APPLICATION FOR ZONING CHANGE

Date 2-25-91NAME OF PROPOSED DEVELOPMENT Steger Retail AdditionLOCATION OF PROPOSED DEVELOPMENT N.E. corner of FM 740 and
FM 3097NAME OF PROPERTY OWNER/DEVELOPER Estate of O.L. Steger, Jr. and Emily Sue
Whitehead
c/o Lakeside National BankADDRESS P.O. Box 9PHONE (214) 771-8311Rockwall, Texas 75087NAME OF LAND PLANNER/ENGINEER Winkelmann & Associates, Inc.ADDRESS 12800 Hillcrest Road, Suite 200PHONE (214) 490-7090Dallas, Texas 75230TOTAL ACREAGE 4±CURRENT ZONING ANUMBER OF LOTS/UNITS 1PROPOSED USE FOR DEVELOPMENT Grocery Store

FOOD LION, INC. SITE #50a
F.M. 740 @ F.M. 3097
Rockwall County
Rockwall, Texas

JOB NO.	06416.01
DATE	2-18-91
DRAWN	A.J.L./A.L.C.
CHK.	M.D.C.
DISC.	6416Site.Dwg
SHEET OF	1 of 1
LANDSCAPE PLAN

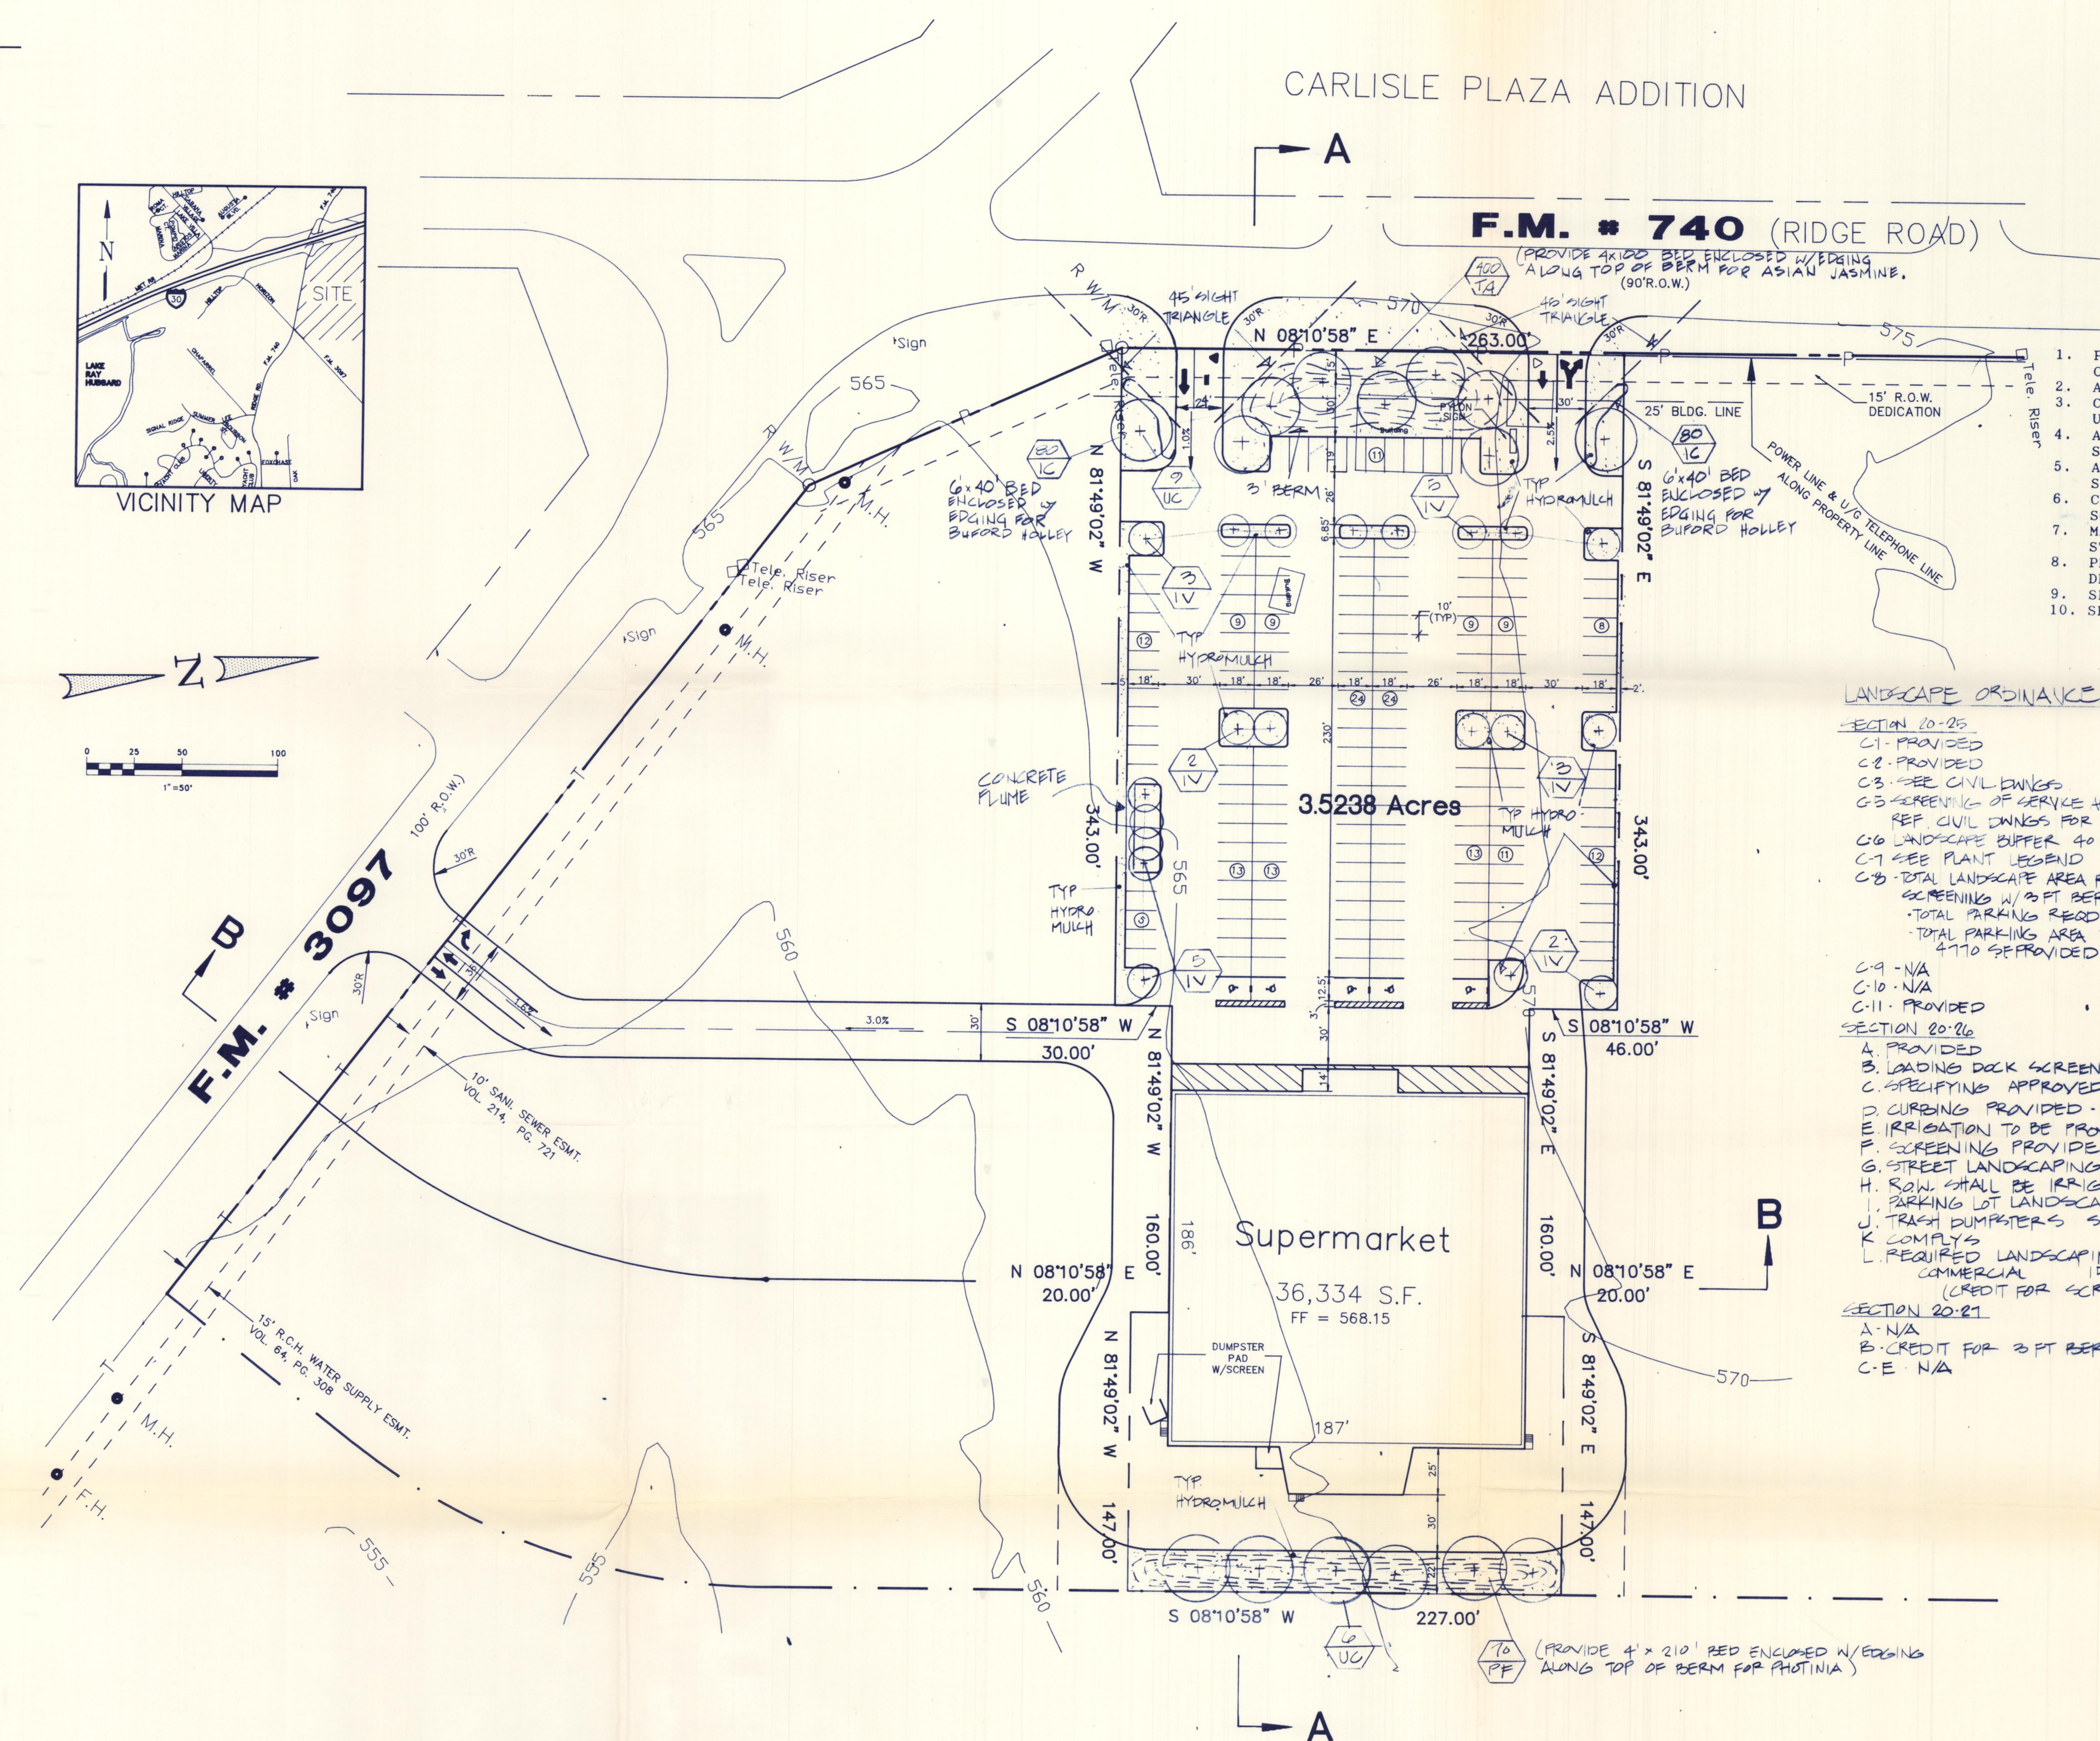
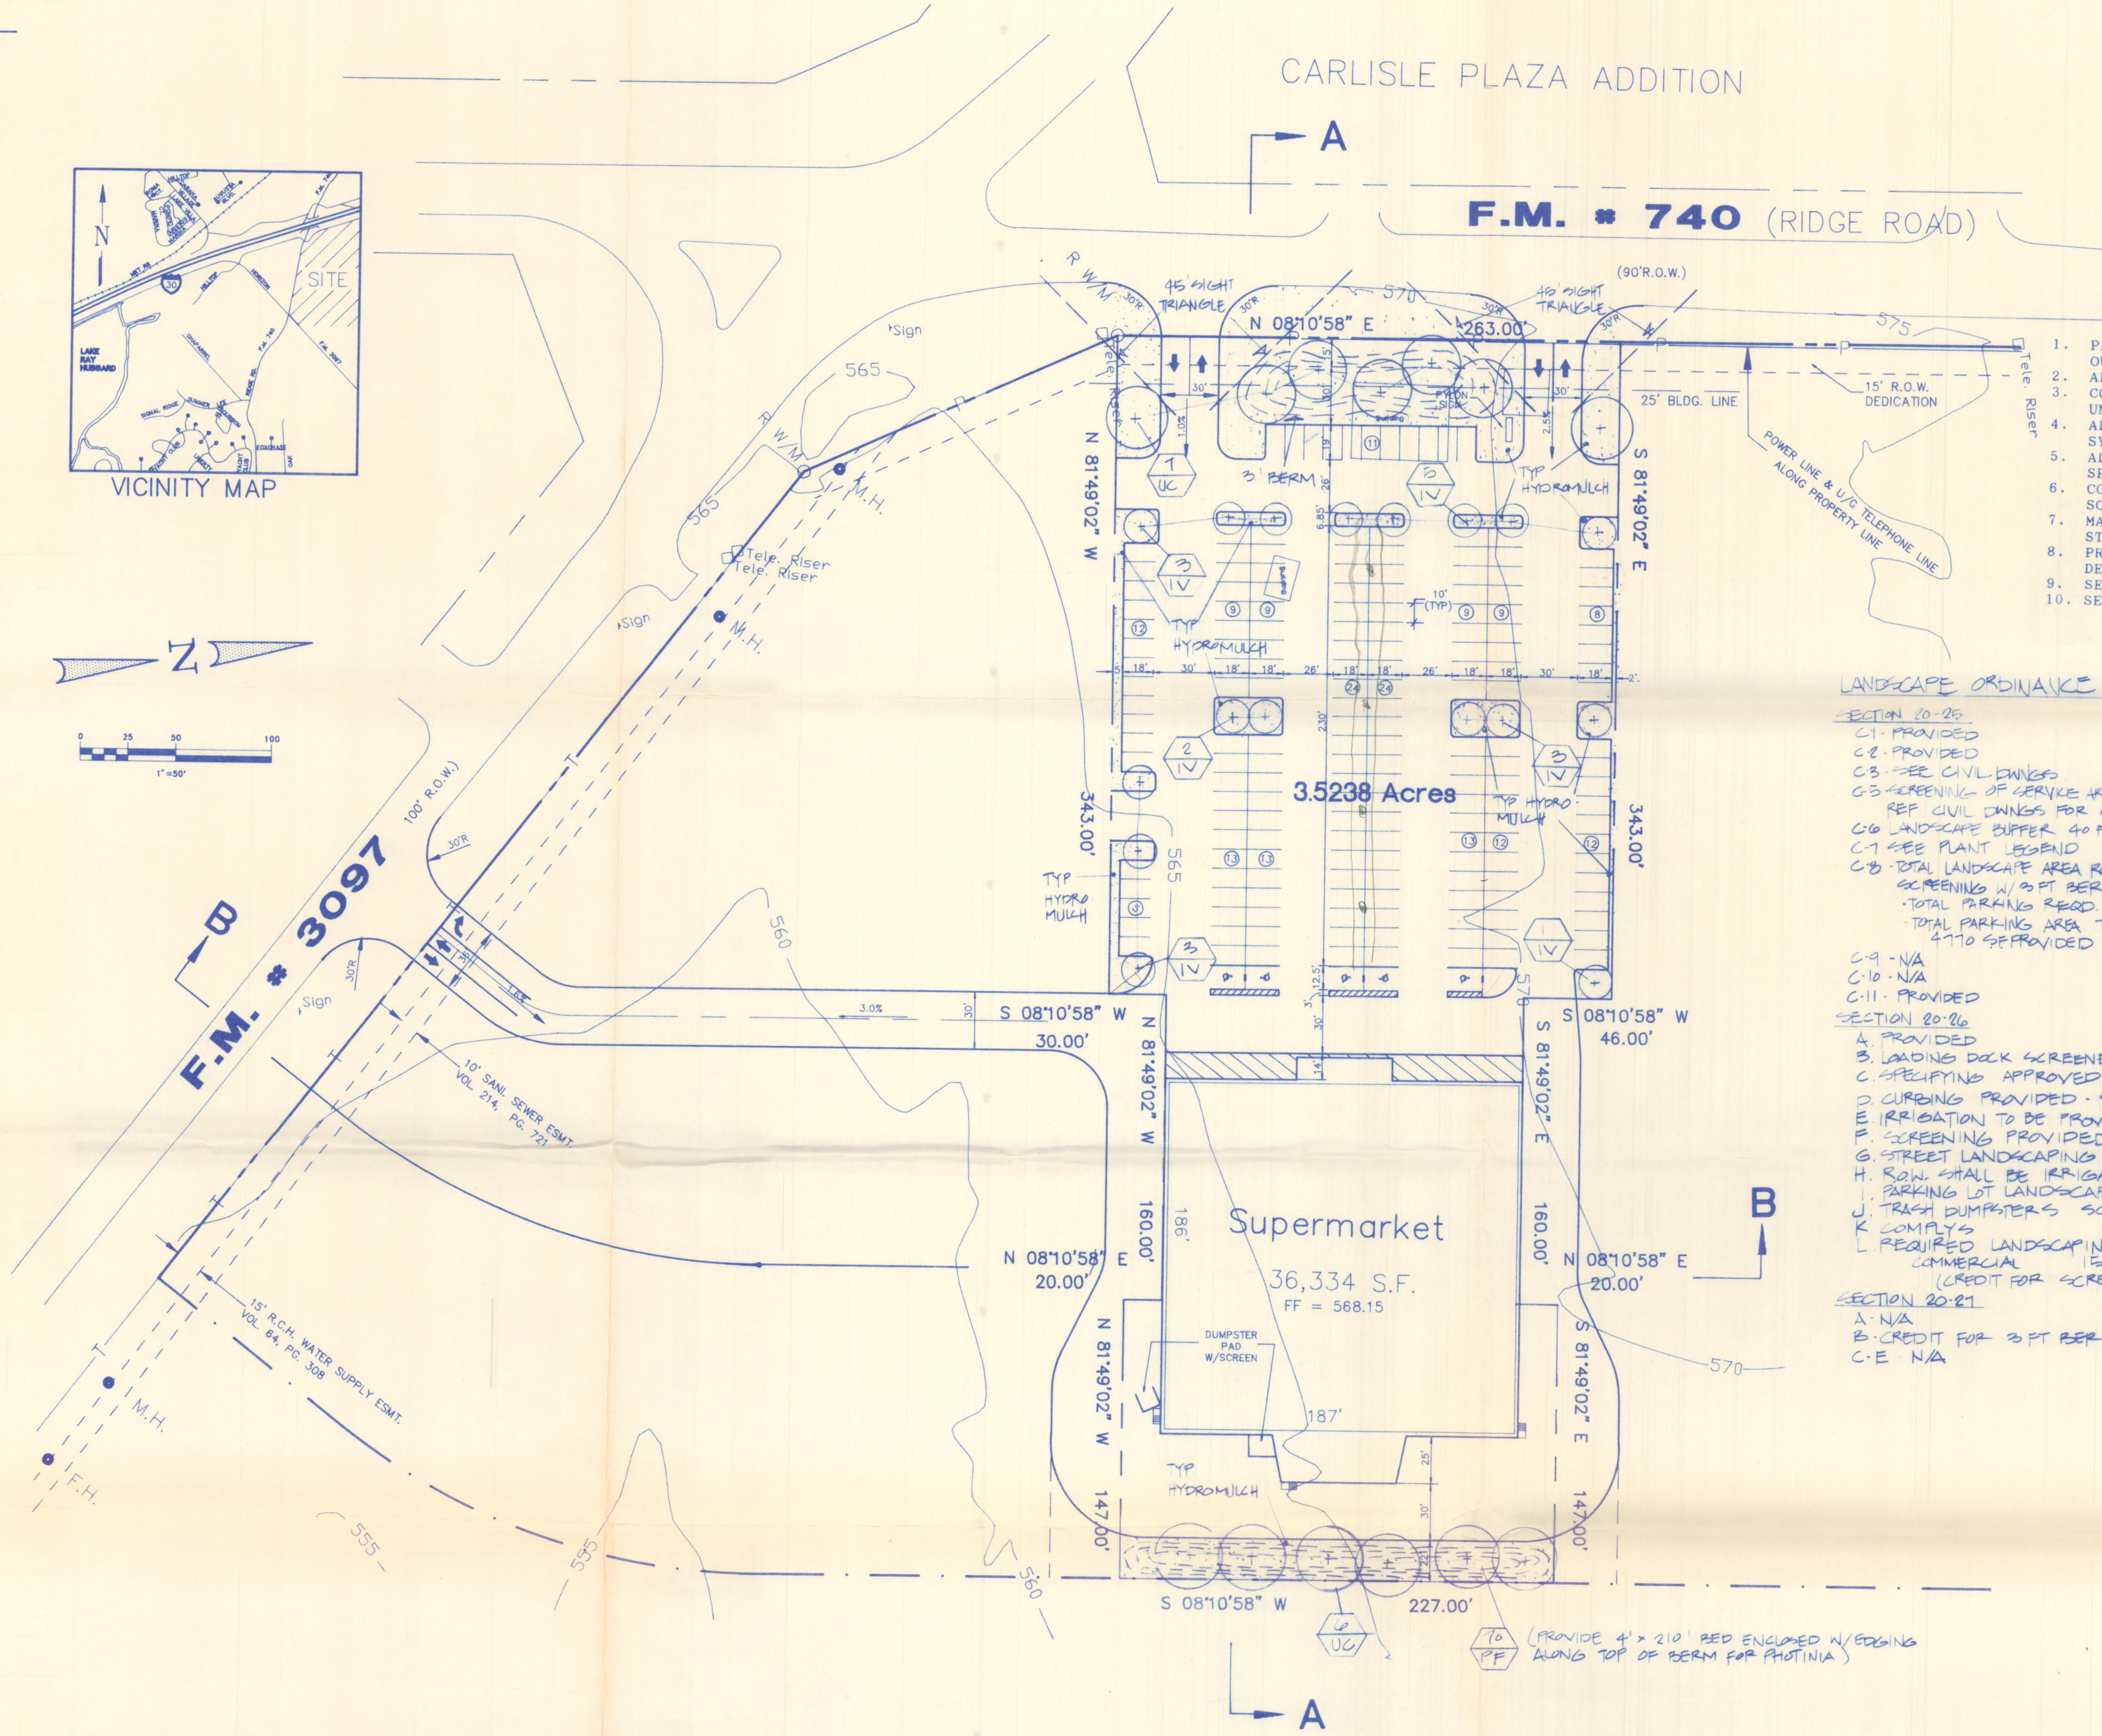
Landscaping Plan

1. The total site requirement for landscaping is 18,708 sq. ft. In reviewing the plan I find approximately 16,600 sq. ft. Please identify the area of the individual landscaped areas. The area to be dedicated as ROW for FM-740 cannot be included in the calculation. I would recommend that you consider including an 8 foot strip between the two center parking stalls. This would provide the additional landscaping area and would enhance the parking lot.
2. You have reduced the percentage of required landscaping by including a 3 ft. berm in the front of the tract. Please identify what landscaping will be planted on

the berm in addition to the required street trees. I would encourage some low maintenance ground cover or low shrubs along the top of the berm. You will need to add 3 foot evergreen shrubs in front of the parking lot on either side of each entrance to fully gain this credit.

4. You need to add 2 more trees along the frontage. In the Overlay District the ratio is one tree per each 30 feet of frontage.
5. You are showing 17 yaupon holly trees internal to the parking lot. These are classified as small trees under our landscaping ordinance. The ordinance provides that one large tree per every 20 parking spaces be provided. This may be considered an equivalent exchange by the Commission, which will be discussion at the meeting.

LANDSCAPE PLAN

1. Winkelmann & Associates, Inc.'s calculations indicate a total of 17,642 square feet of landscape area on the plan as originally submitted. We have eliminated an unnecessary drive to "pick up" 600 S.F. and modified a radius to lose on parking space to "pick up" 180 S.F. and narrowed one drive to "pick up" 360 s.f to provide a total of 18,782 S.F.
- 2 & 4. Modifications have been made in accordance with comments.
5. Information only.
